Southern Nuclear Operating Company
Joseph M. Farley Nuclear Plant Units 1 and 2;
Edwin I. Hatch Nuclear Plant Units 1 and 2;
Vogtle Electric Generating Plant Units 1 and 2;
License Amendment Request for Changes to
Emergency Action Level Schemes to Adopt NEI 99-01 Rev. 6
and to Modify Radiation Monitors at Farley Nuclear Plant
Responses to Requests for Additional Information

ENCLOSURE 3

MARKED-UP PAGES

Southern Nuclear Operating Company
License Amendment Request for Changes to
Emergency Action Level Schemes to Adopt NEI 99-01 Rev. 6
and to Modify Radiation Monitors at Farley Nuclear Plant
Responses to Requests for Additional Information

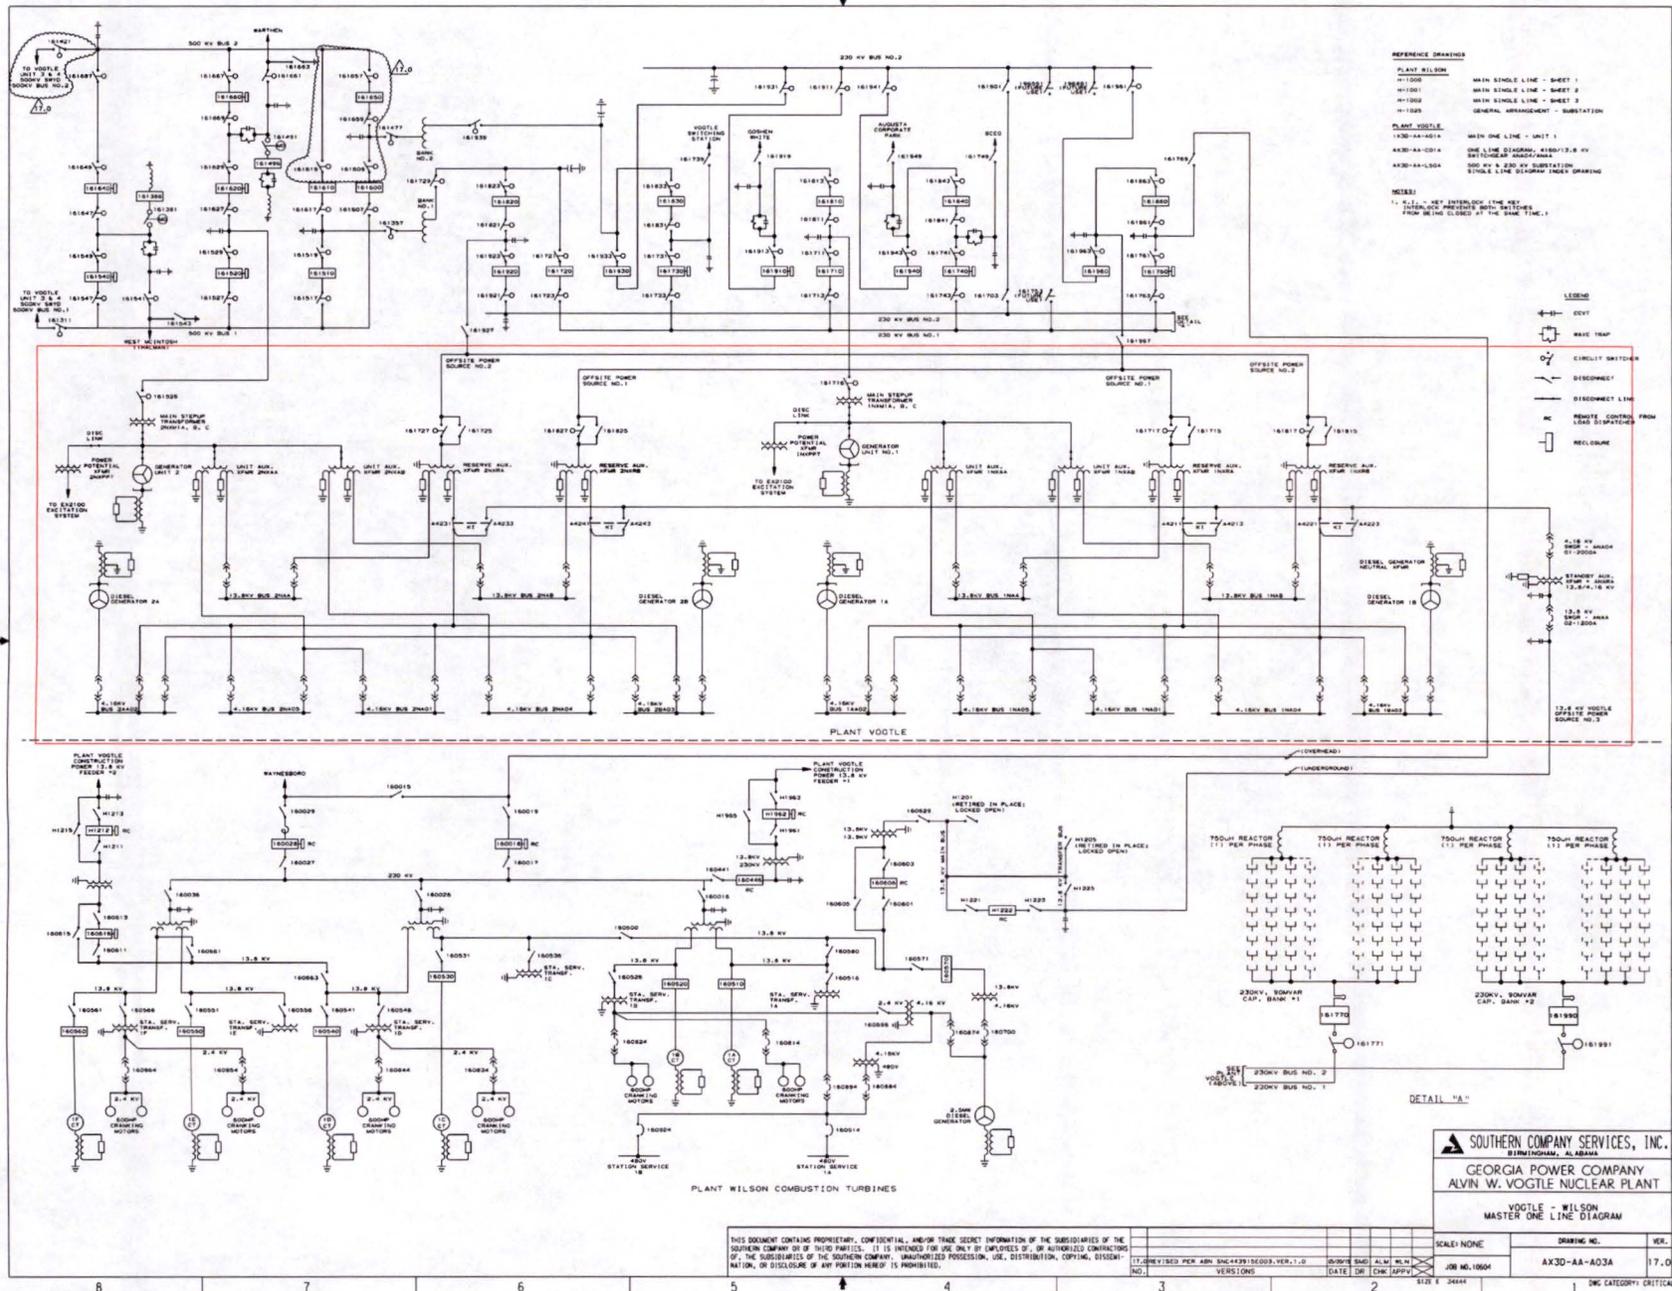
Commented [JRB1]: Renumbered V&V#'s due to deletion of previous V12 – Containment Pressure Reference: ≥ 13 psig with Containment Closure established, ≥ 52 psig with TS Containment Integrity Intact *Calc X6CNA15*. Deletion was implemented in response to RAI 11.

Commented [JRB2]: RAI 23 revision

Commented [JRB3]: RAI 28 revision
